Watts Bar Nuclear Plant, Unit 2  
NRC Docket No. 50-391

**Subject: Watts Bar Nuclear Plant (WBN) Unit 2 – Additional Responses to Request for Additional Information Regarding (1) Large Break Loss of Coolant Accident, (2) Steam Line Break, and (3) Miscellaneous Analysis**

**Watts Bar 2 (WBT) Responses to Remaining RAI  
from NRC Staff Audit Report**

# **Response to March 15, 2011 NRC Audit Questions on Steam Line Break Analysis for Watts Bar Unit 2**

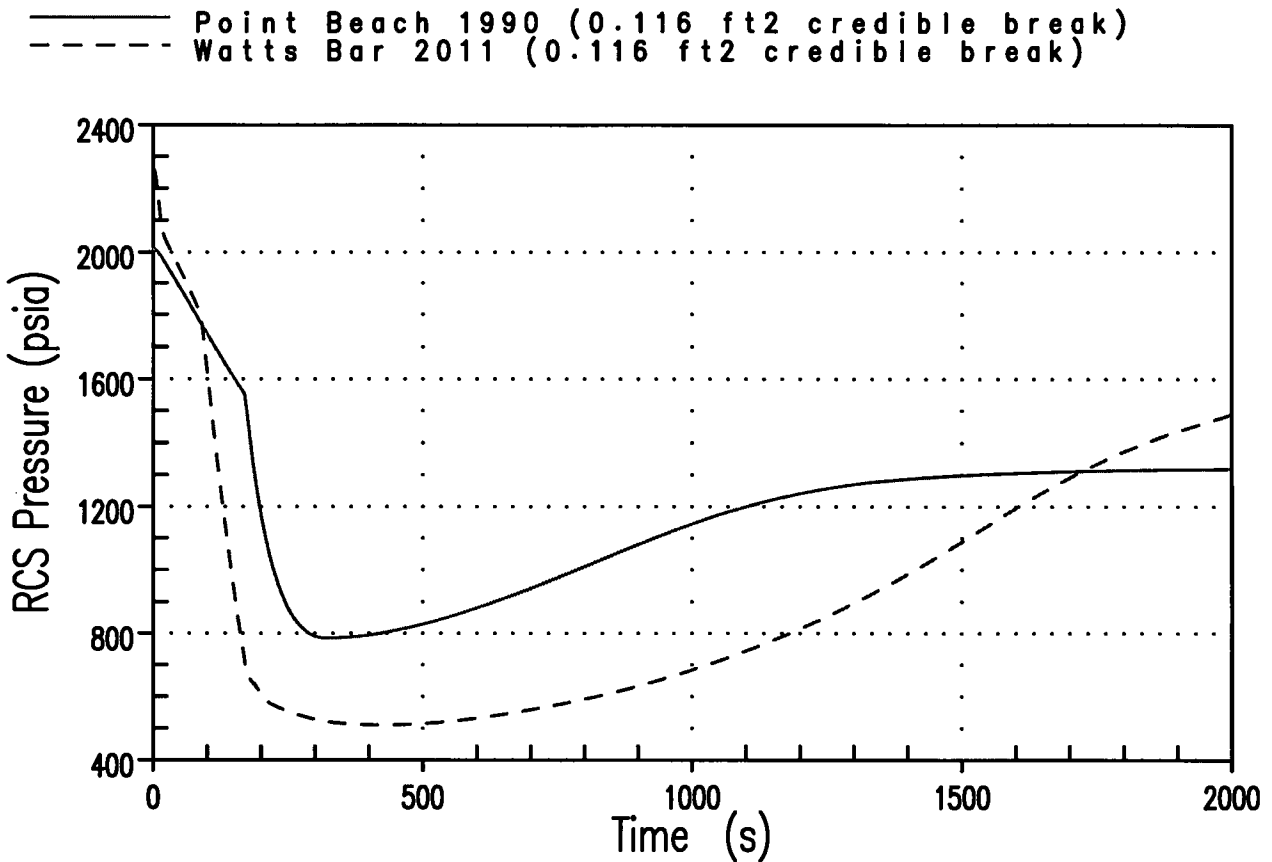
The NRC has illustrated the concern of a small break that reaches a minimum pressure above the accumulator setpoint via the Point Beach analysis from 1990, as documented in WCAP-12603. At the time, Westinghouse analyzed cases for both hypothetical breaks (large DER of the main steam line) and credible breaks (inadvertent opening of a steam generator safety or relief valve). The 1990 analysis of the credible steam line break modeled a break size of 0.116 ft<sup>2</sup> that does not depressurize the RCS to the accumulator actuation pressure.

A comparison of the Point Beach model and the Watts Bar model revealed that the two cases modeled the break differently. For Point Beach, the break is modeled as a stuck open valve on one loop (non-uniform credible break). The break is asymmetric in that it only affects one steam generator. For Watts Bar, the break was modeled in the same manner as the hypothetical break case, i.e., as a small DER with blow down from all loops until steam line isolation, after which the break flow is terminated from all but one steam generator.

The RCS pressure transient in the 1990 Point Beach credible break case bottoms out a little below 800 psia and then begins to increase. The LOFTRAN input file from that analysis was obtained and the transient was run out to a longer time. To ensure a consistent comparison, an additional Watts Bar SLB case has been run with the break modeled as a stuck open valve of the same flow area as in the Point Beach analysis. The RCS pressure transients are shown in the transient plot below. As shown, for Watts Bar the accumulator setpoint is reached for a credible steam line break of 0.116 ft<sup>2</sup>. Pressure decreases to a little above 500 psia. There is no return to power for this case, which is not surprising since the large DER case shows a low return to power for this plant and the same reactivity feedback characteristics are used. The credible break case is bounded by the large DER case presented in the Watts Bar Unit 2 FSAR, as expected.
